SEWAGE DISPOSAL SYSTEM

HOWARD COUNTY HEALTH DEPARTMENT
BUREAU OF ENVIRONMENTAL HEALTH
461-9933

SUBDIVISION Triadelphia Farms, II LOT 1-B ROAD 13364 Hunt Ridge

REPAIR - PURPOSE - TO PROVIDE ADDITIONAL SEPTIC CAPACITY CONSISTENT WITH REQUIREMENTS OF
3 BEDROOM ADDITION - BUILDING PERMIT NUMBER: 44024
INSTALL: 100' additional trench with 5 1/2 feet of stone. Maximum bottom trench
depth - 10 feet below original grade. *OK/W*

SITE PLAN
1" = 30.00'

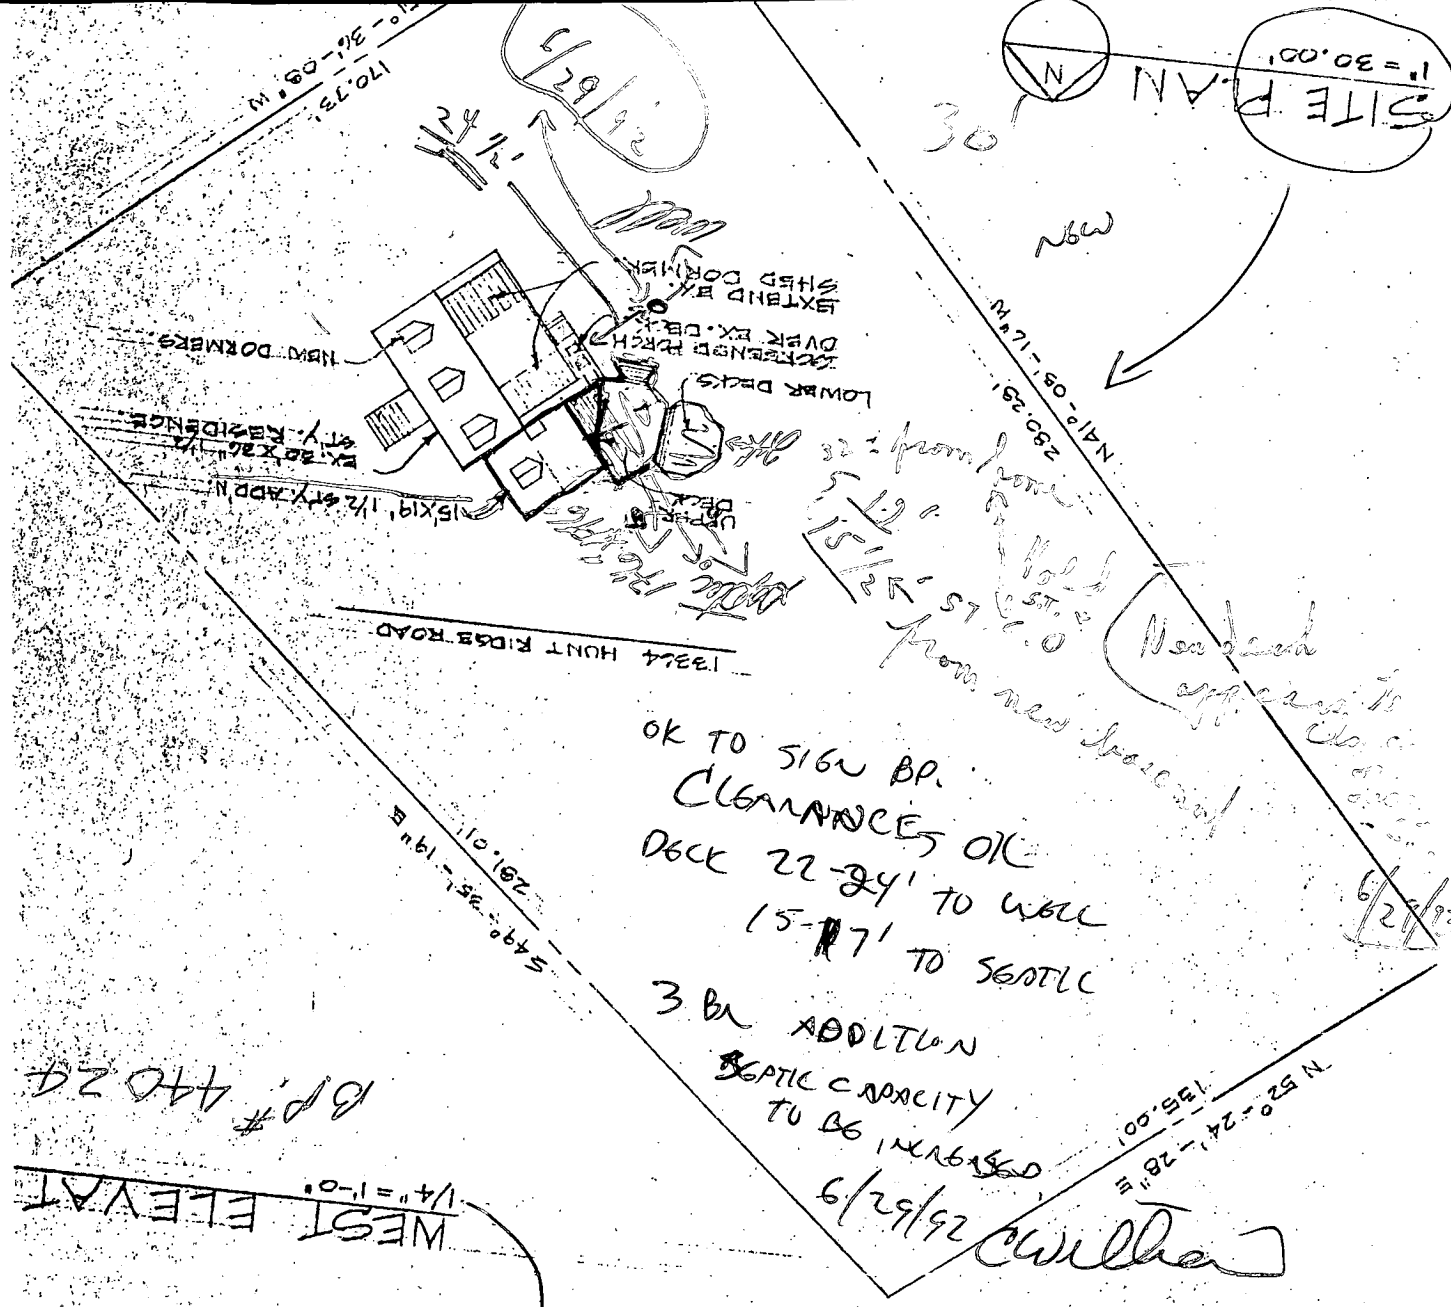
OK TO SIGN BP.
CLEARANCES OK
DECK 22-24' TO WALL
15-17' TO SEATTLE
3 BR ADDITION
SEATTLE CAPACITY
TO BE INCREASED

6/29/92
New deck
from new driveway
held
15.15-15.15
15.15-15.15
15.15-15.15

HUNT RIDGE
HOWARD COUNTY, MD
SCALE: 1" = 30'

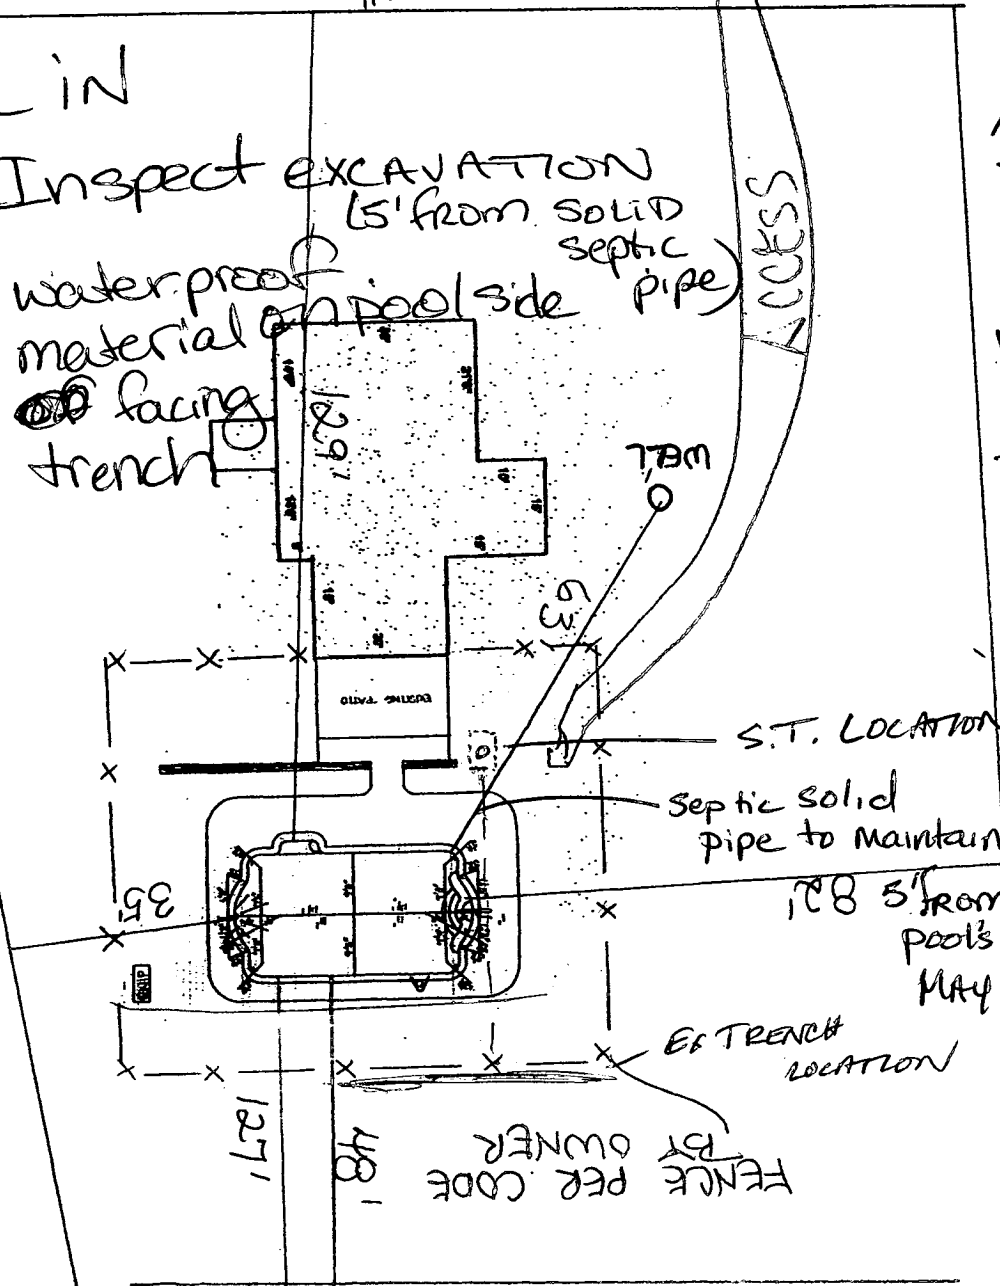
This letter is to request a variance for an in ground pool located at 13364 Hunt Ridge in Ellicott City, Maryland. The existing trench is not in the SDA even though the perc was established prior to its installation. On August 30, 2004 a sanitation inspector came to inspect the tank and the trench area and found them to be functioning properly. We request a variance from the setback to be 15' to the in ground pool to the trench. The pool will be lined with waterproof material. We propose to maintain 10' from septic tank and will call for inspection of the septic line and soil integrity. All future trench repair will be done in approved SDA.

10' SETBACK
FROM S.T.
TOP OF POOL'S EDGE
OK

Variance letter
for SETBACK
TO EX. TRENCH
15' OK w/
PROVISIONS &
INSPECTION
OF SOILS
PRIOR TO
POURING OF
CONCRETE

10' 5" FROM
POOL'S EDGE
MAY NEED
TO ADJUST
(KN)

- ① Inspect EXCAVATION (5' from SOLID septic pipe)
- ② water proof material on pool side facing trench
